**Planning Board Meeting
September 26, 2023 – 7:00 PM
Town Office Conference Room**

Formal Site Plan – Poland Animal Hospital (VetCor of Poland) – 1195 and 1197 Maine Street
– Map 39 Lots 29 and 30

On behalf of VetCor of Poland, LLC, Sebago Technics, Inc (Sebago) is pleased to submit the enclosed plans and supporting application materials for a Site Plan Review to expand the Poland Animal Hospital located at 1195-1197 Maine Street, Tax Map 39 Lots 29 & 30. We respectfully request placement on the next available Planning Board agenda that allows sufficient time to review the application materials, either August 22, 2023 or September 12, 2023.

3. Sheet 5 or 11 – Grading & Utility Plan:

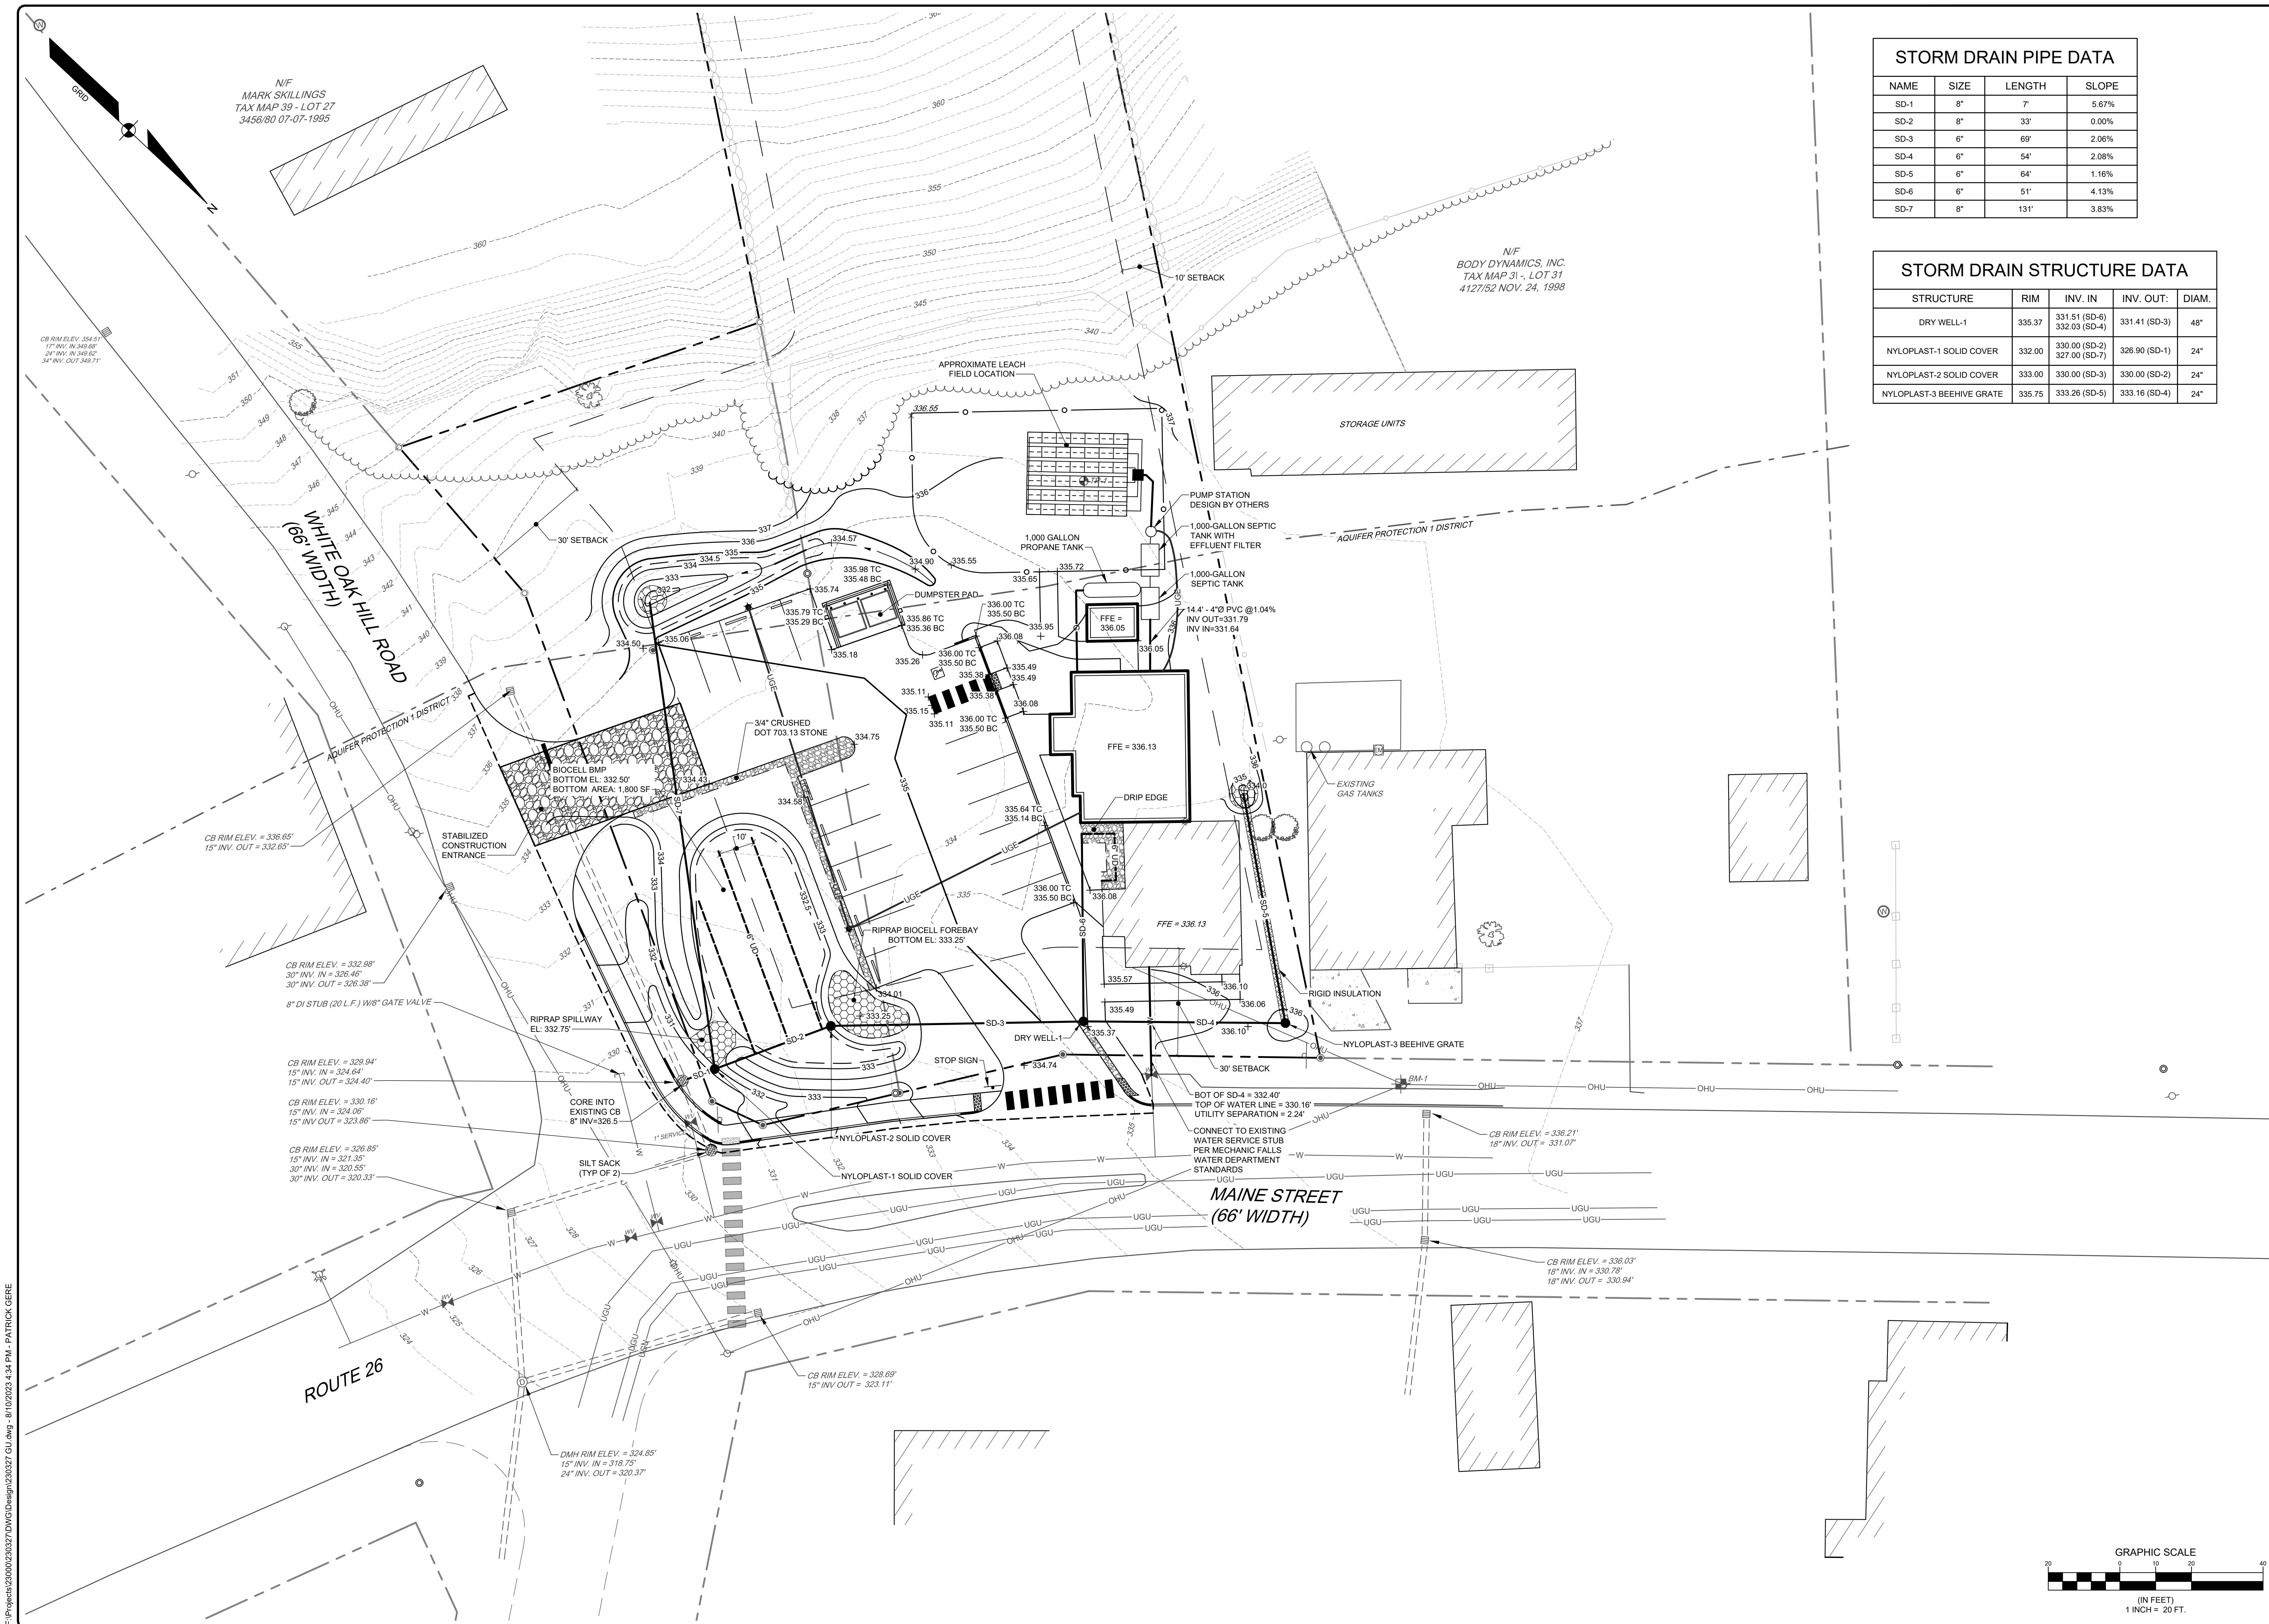
1. Test pits identifying separation to seasonal high groundwater and confirmation that an impermeable liner is not required for the bioretention filter for the project have not been included within the submission.
2. Indicate the peak elevations for the 2, 10, and 25-year storm events on the bioretention filter detail included on sheet 11 of 11.
3. The stormwater report provides information that BMP sizing and treatment calculations are provided in Appendix 1. It appears that the water quality sizing calculations for the proposed BMPs meeting DEP design criteria for the bioretention filter cell, roof dripline filter, and dry wells have not been provided.
